SAN FRANCISCO UNIFIED SCHOOL DISTRICT
FACILITIES DESIGN AND CONSTRUCTION

ADDENDUM NO. 3

PROJECT: **Modernization and Interior Improvements** **DATE:** 4/16/13
At ER Taylor Elementary School
423 Burrows Street, SF, CA 94134

SK1

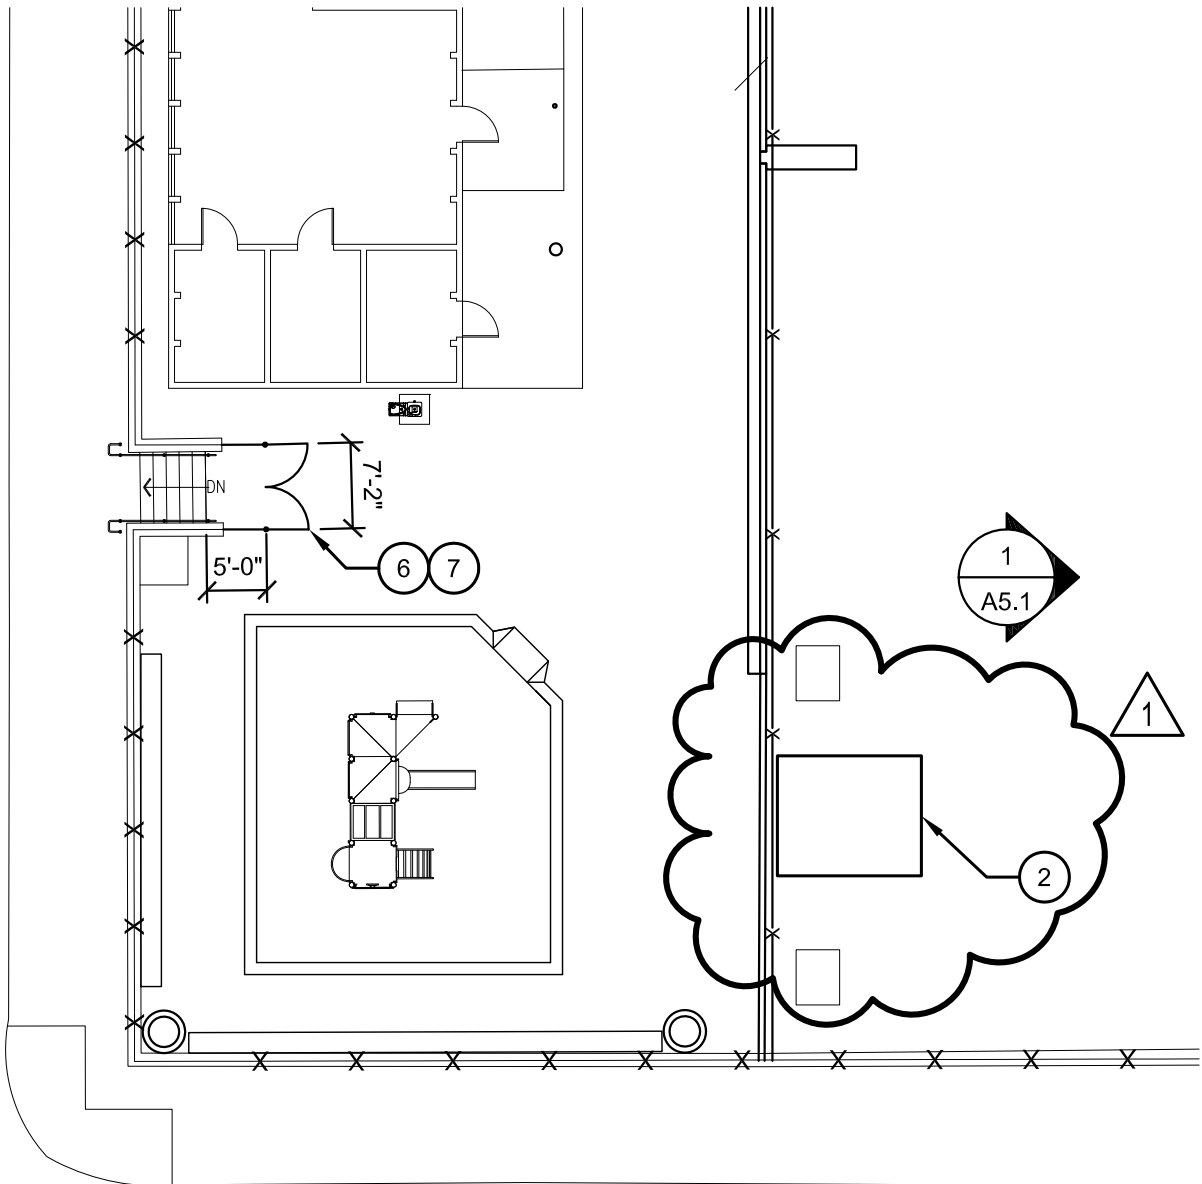
Reference: **DRAWING A-1.1 SITE PLAN**
Description: Location of new tuff shed (sheet note 2) moved from upper yard to lower yard. See attached sketch SK1.

REFERENCE DETAIL: 1/D-2.2

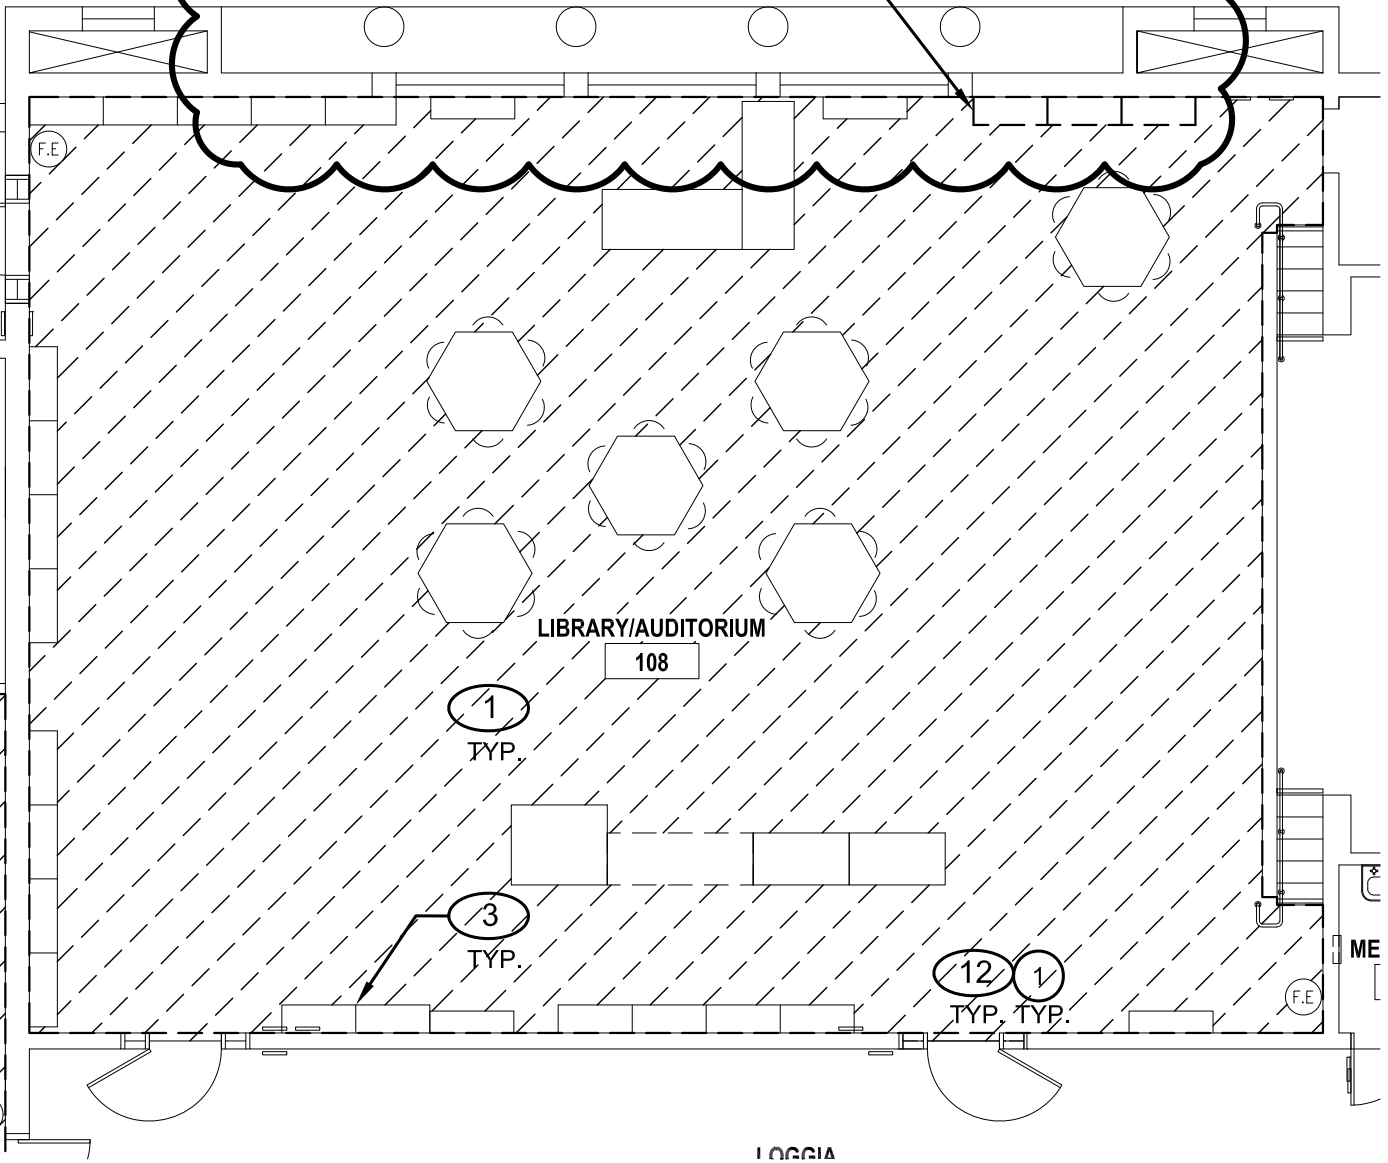
Description: Demo library shelving and relocate electrical and data outlets. See attached sketch SK2.

DEMO (E) LIBRARY SHELVING (3 TYP.), AND
RELOCATE (E) ELECTRICAL (5 QUADS TYP.)
AND DATA OUTLETS (4 TYP.)

REFERENCE DETAIL: 1/A-2.2

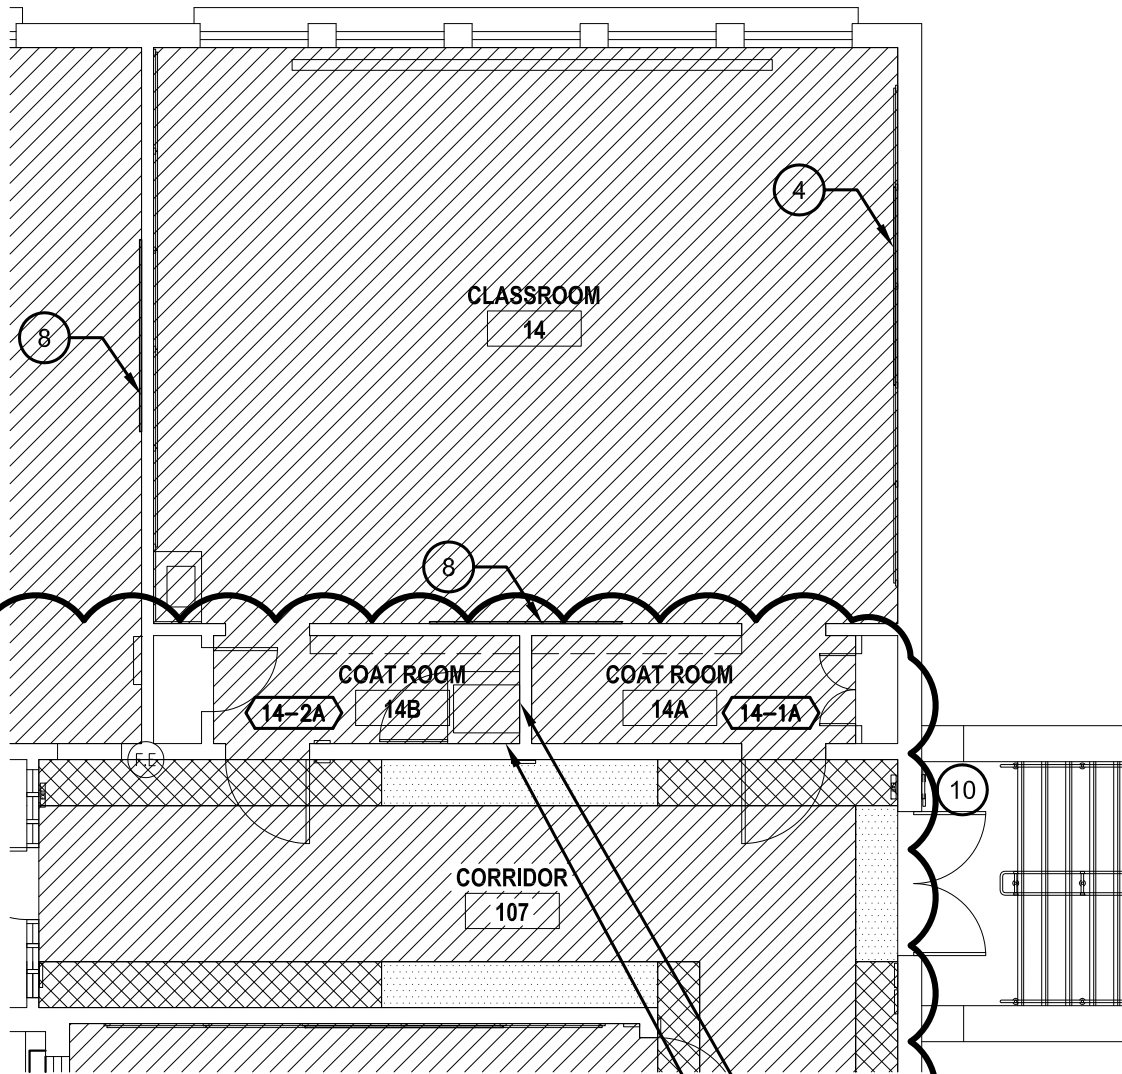
Description: Provide bulk storage locker, double tier, 36"x36"x90" starter with roof. (globalindustrial.com #WG968218) Add duplex electrical outlet from dedicated 15amp circuit. See attached sketch SK3.

PROVIDE BULK STORAGE LOCKER, DOUBLE TIER, 36"X36"X90" STARTER WITH ROOF, GLOBALINDUSTRIAL.COM #WG968218

PROVIDE DUPLEX ELECTRICAL OUTLET FROM DEDICATED 15AMP CIRCUIT

REFERENCE DETAIL: 3A/A-5.3

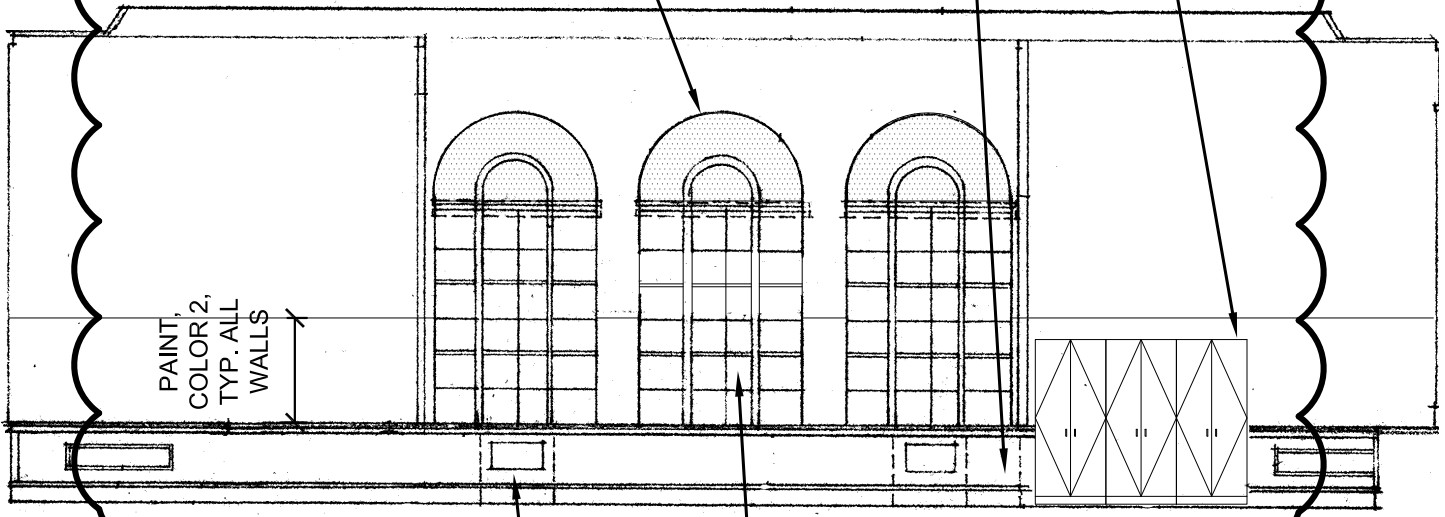
Description: Provide new casework, add window film to arched windows, and additional painting. See attached sketch SK4. Please note that drawings for library interior elevations are not to scale in both bid set and addendum.

CASEWORK, WI 402,
36"X72"X24"

PROVIDE WINDOW FILM,
LLUMAR N1020B SR CDF AT
ARCHED WINDOW SECTION

RELOCATE (E) ELEC AND
DATA OUTLET

PAINT,
COLOR 2,
TYP. ALL
WALLS
